SERVICE INSTRUCTION

REPLACEMENT OF THE CIRCLIP IN THE SPRAG CLUTCH HOUSING ON ROTAX® ENGINE TYPE 912 AND 914 (SERIES)

SI-912-006 R1

SI-914-008 R1

see fig. 1 and 2

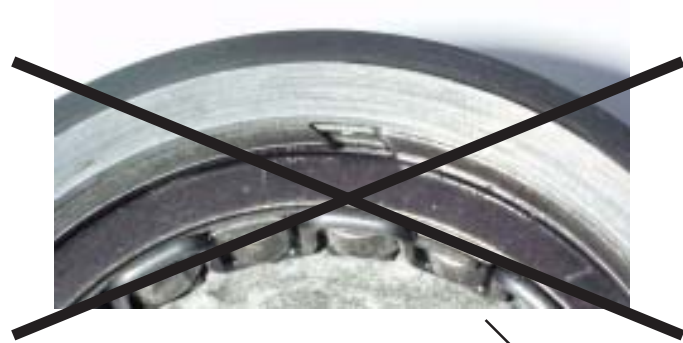
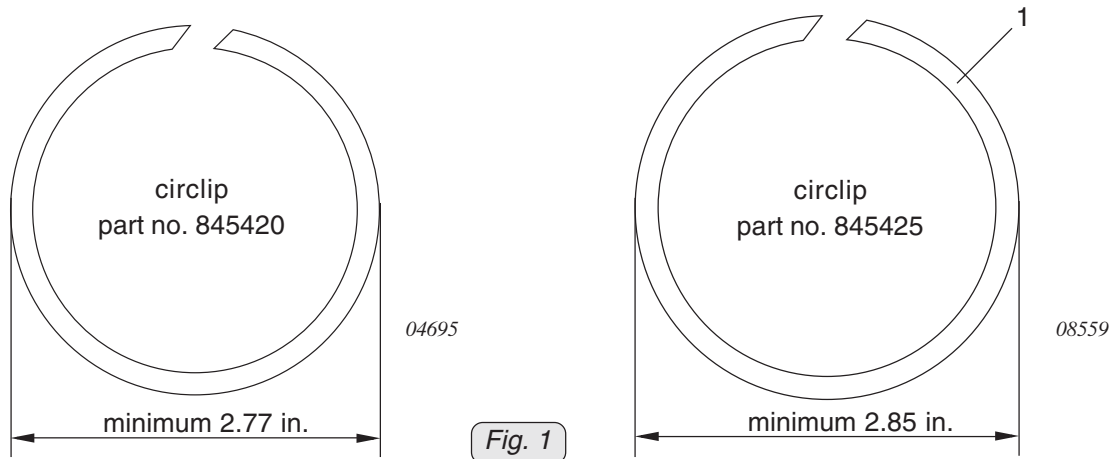
- At exchange take care of the following:
As the new circlip is slightly bigger as the one fitted previously, the end gap on the new circlip is smaller.
- all used parts and spare parts are unserviceable and must be scrapped.

On repair work on sprag clutch (2) or at engine overhaul the circlip 68 part no. 845420 has to be replaced by the circlip 70 (1) part no. 845425. Verify by inspection if the new circlip 70 is already fitted. See fig. 1

DETAIL A: shows the correct position of the circlip

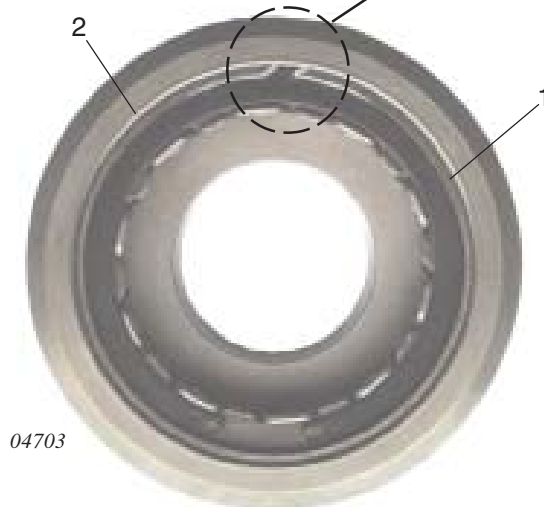
■ **CAUTION:** Make sure that the new circlip will be fitted as depicted in fig. 2 Detail A. To warrant a tight fit pay attention to correct position of the circlip ends (3).

DETAIL B: shows the incorrect position of the circlip
